Design Review Update

Parcel W

Reference: Parcel W Design Review
Cambridge Crossing
Cambridge, Massachusetts

CAMBRIDGE PLANNING BOARD ON NOVEMBER 13th, 2018

3. MECHANICAL LOUVER LOCATIONS

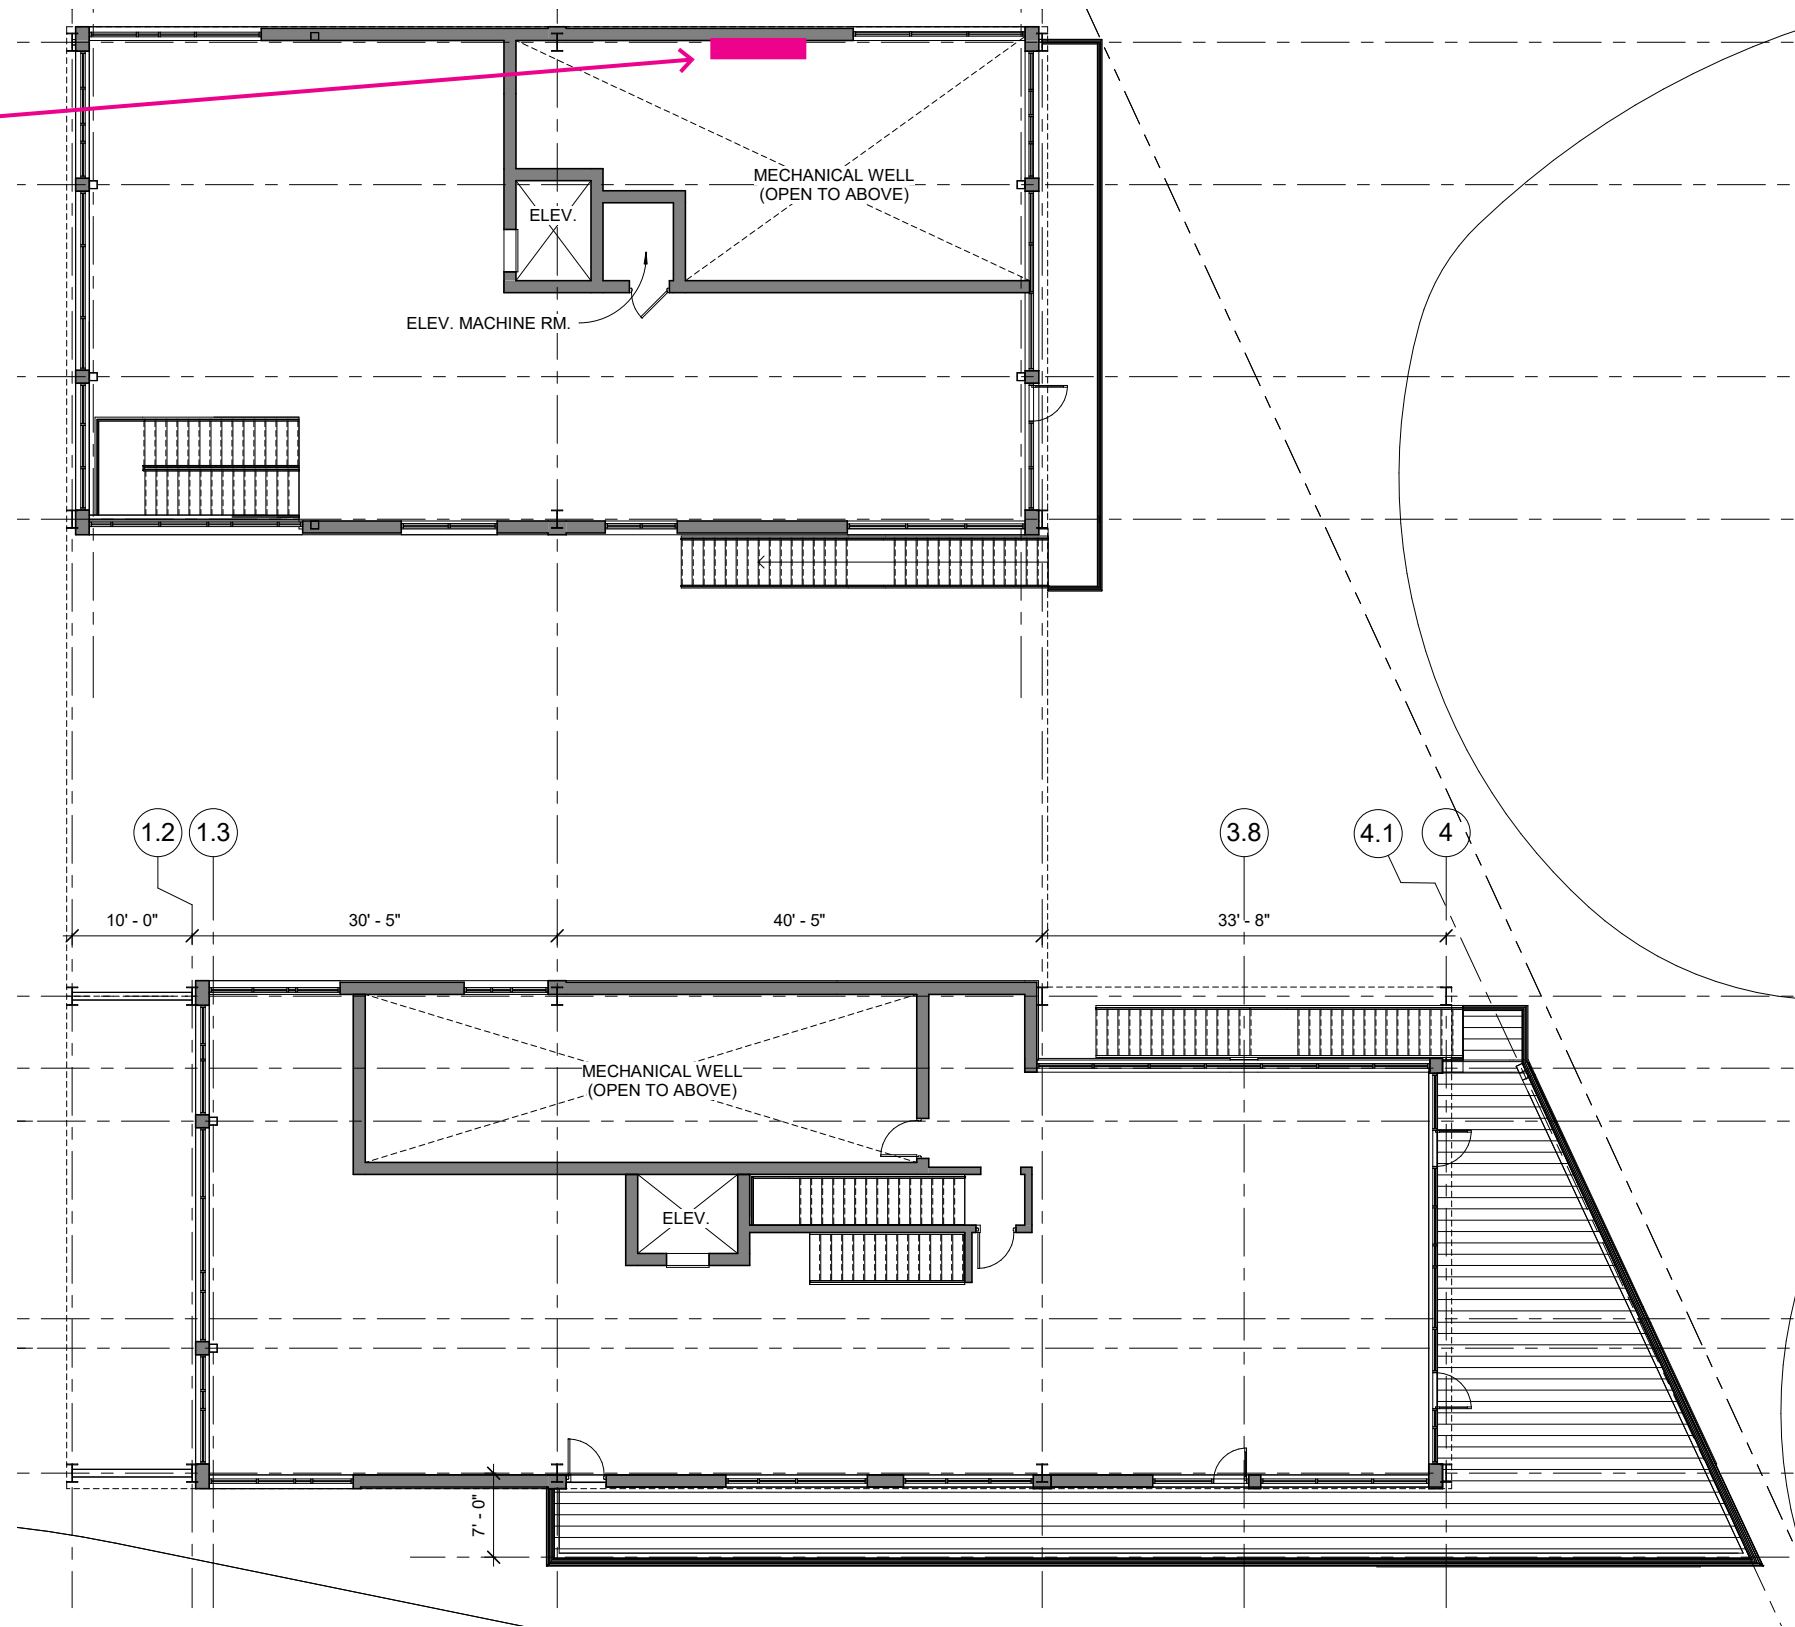
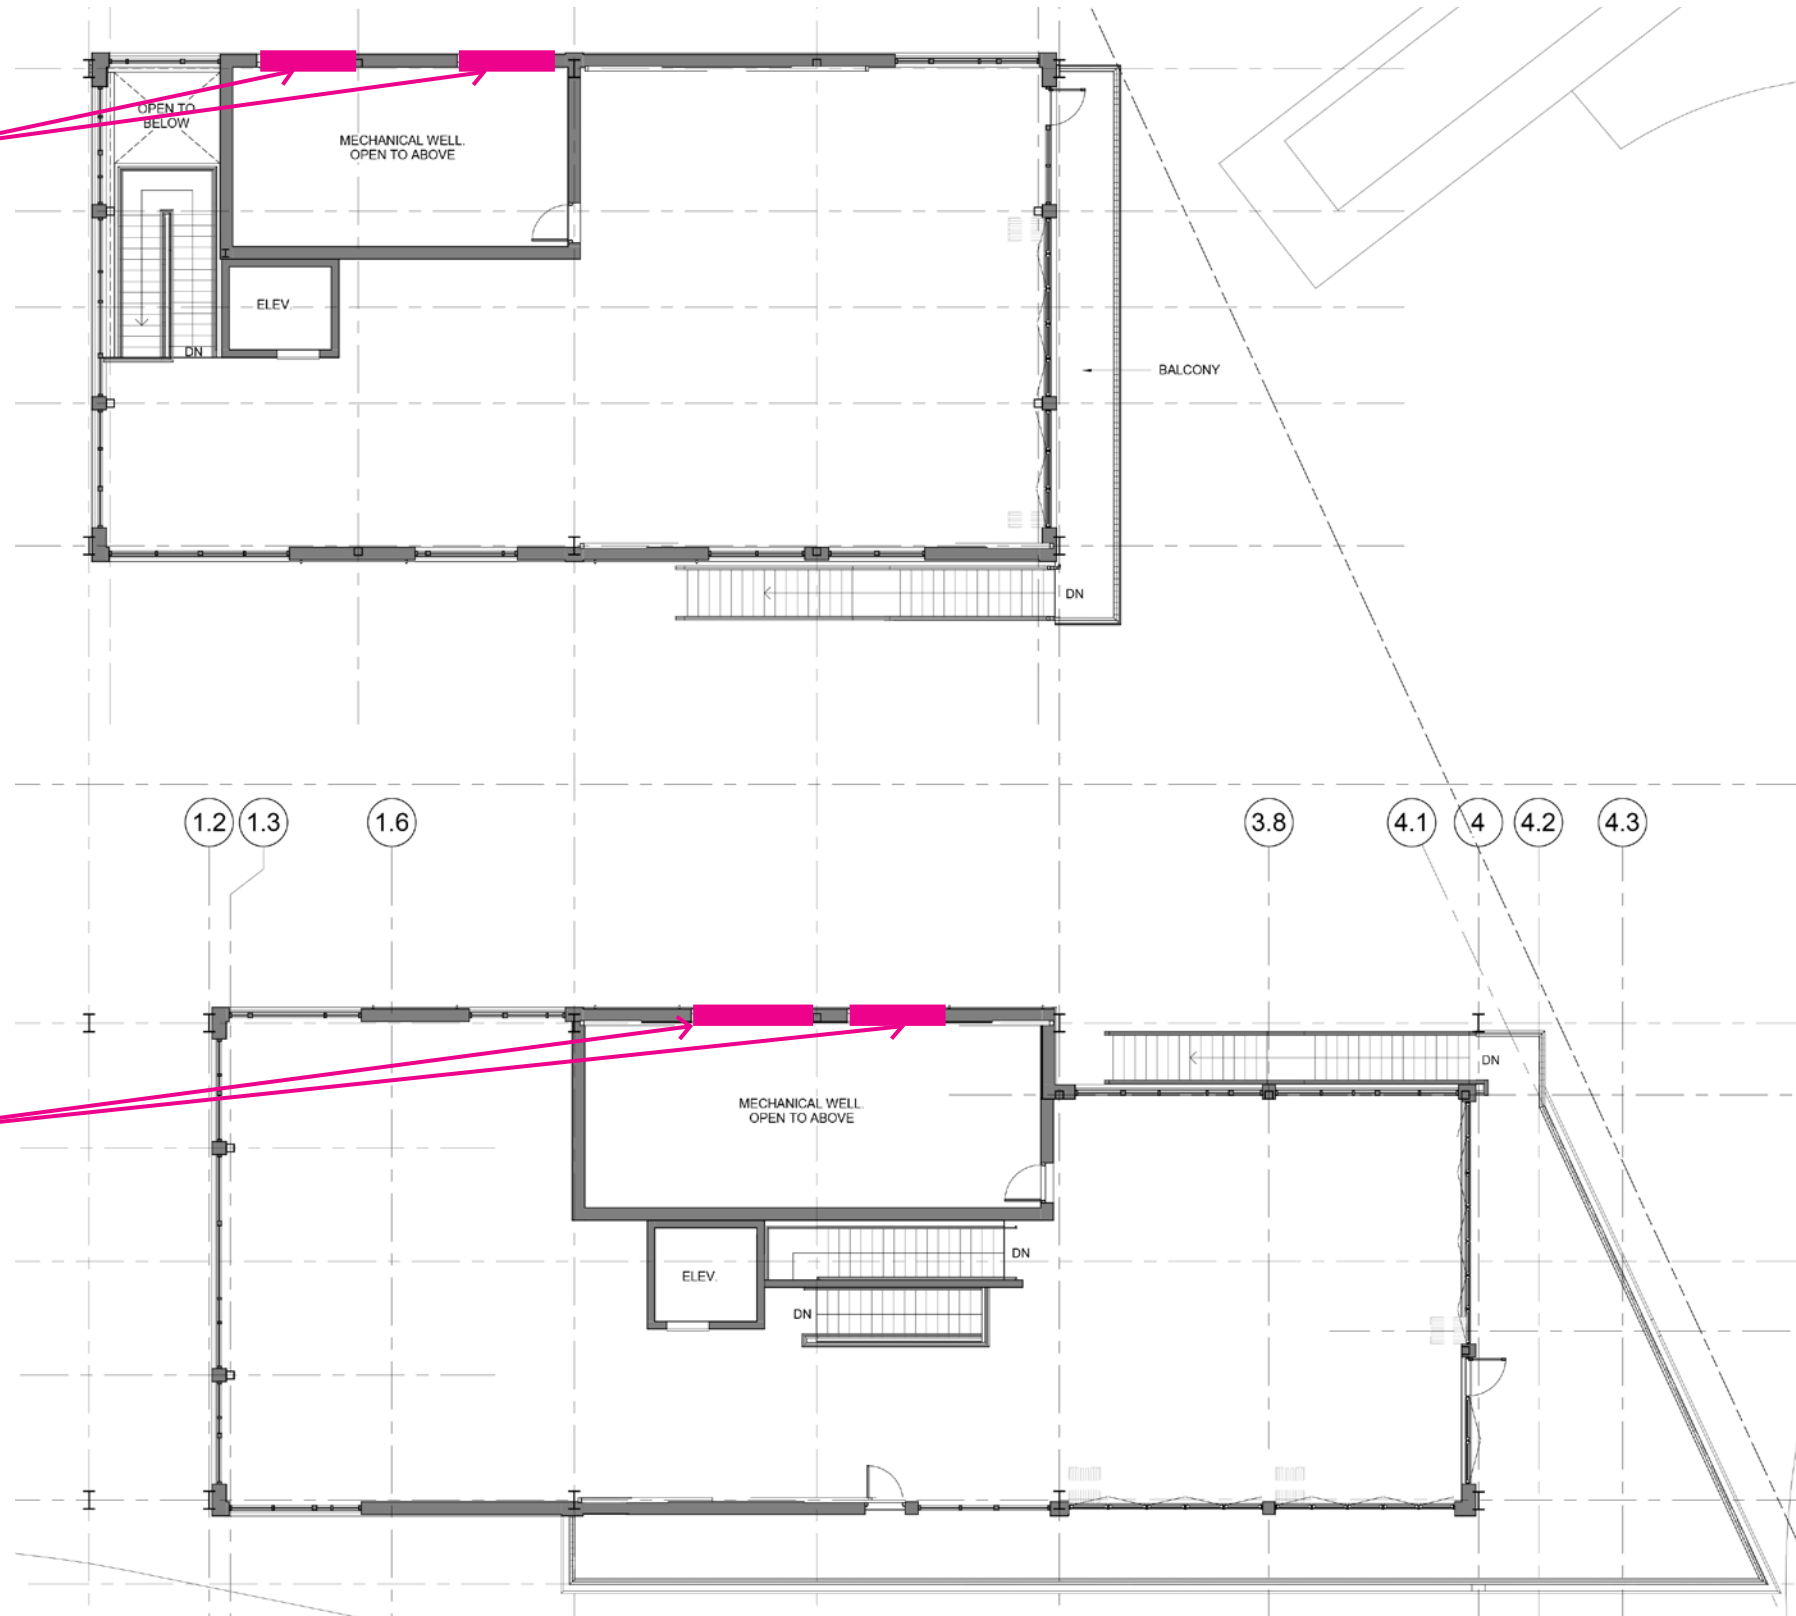
The location of mechanical louvers should be carefully considered. To the greatest extent possible, all kitchen exhaust should vent through the roof and not to the public realm.	The building design places the mechanical system inside a recessed well instead of exposed on a roof or at grade, both of which would have negatively impacted the public realm. In order to be the most energy-efficient, space-efficient, and create the least amount of noise, the mechanical system design requires air intake louvers on the sidewalls of the buildings. The units exhaust directly upwards only. The louvers are completely separate from the kitchen exhaust system which only vents directly upwards.	12-15
<i>Additional GFA</i>		
The Special Permit allows up to a 10% change in GFA on any site as part of the design review process. The additional GFA related to the canopy structures and revisions to the mechanicals is relatively minor and is less than 10% of the GFA approved for Parcel W.	No action required.

Louvers added on North sides of buildings adjacent to mechanical areas (least prominent side of each building)
 For mechanical intake only, exhaust remains through roof only

Louvers added on North sides of buildings adjacent to mechanical areas (least prominent side of each building)
 For mechanical intake only, exhaust remains through roof only

2017 APPROVED NORTH ELEVATION AT CENTER BAY

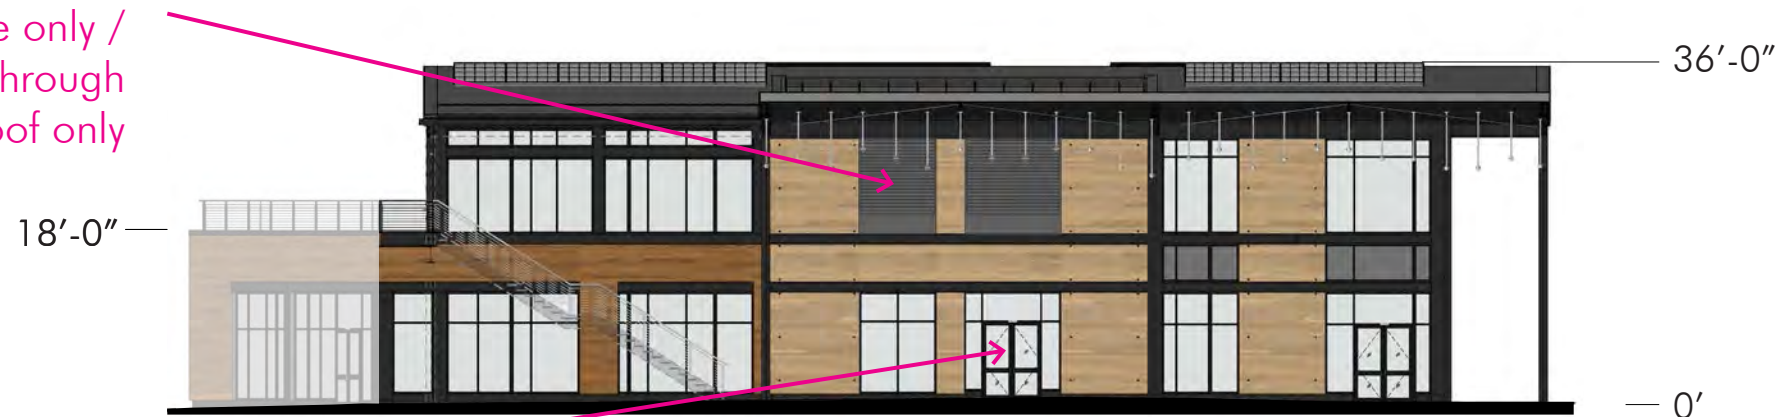
3. MECHANICAL LOUVER LOCATIONS

Louvers added on North sides of buildings adjacent to mechanical areas for mechanical intake only / Exhaust remains through roof only

2017 APPROVED NORTH ELEVATION

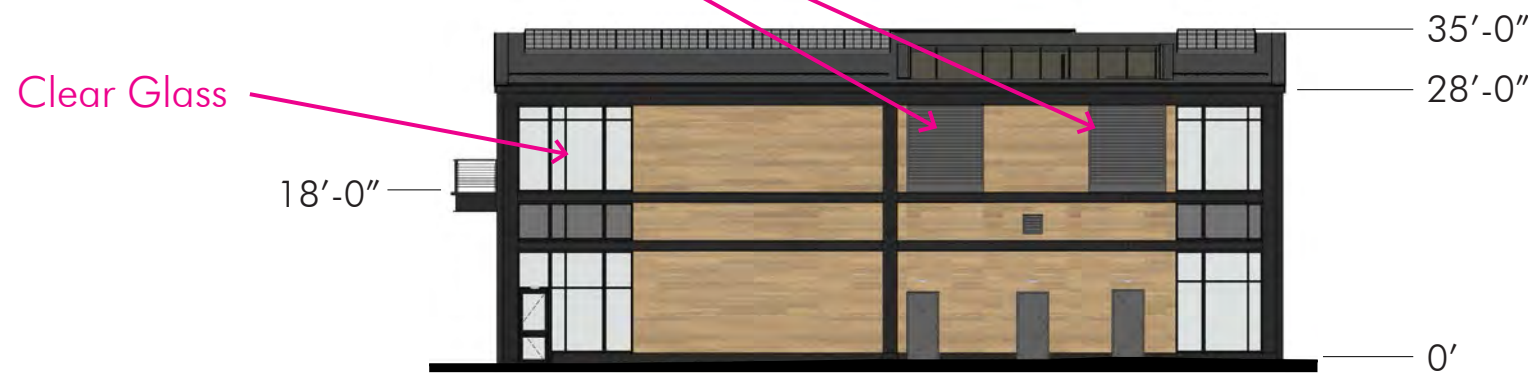
3. MECHANICAL LOUVER LOCATIONS

Louvers relocated on North sides of buildings adjacent to mechanical areas for mechanical intake only / Exhaust remains through roof only

2017 APPROVED SOUTH ELEVATION AT CENTER BAY

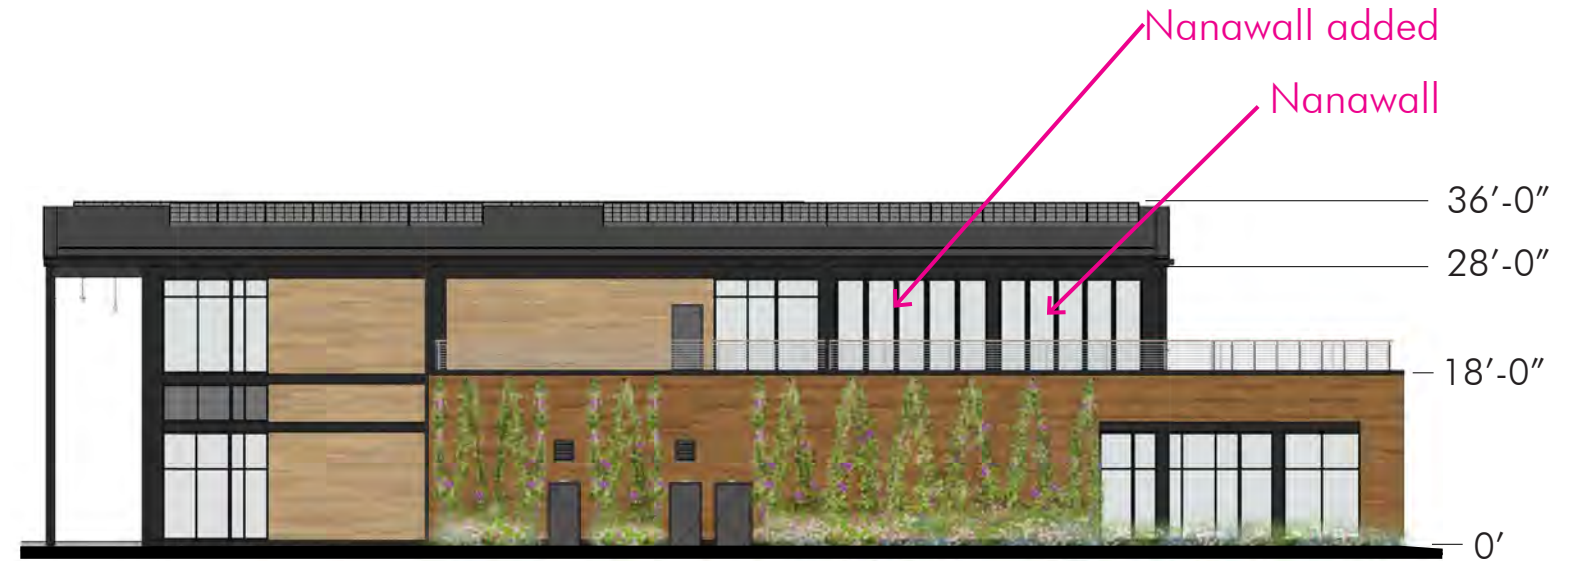
4. NANAWALL
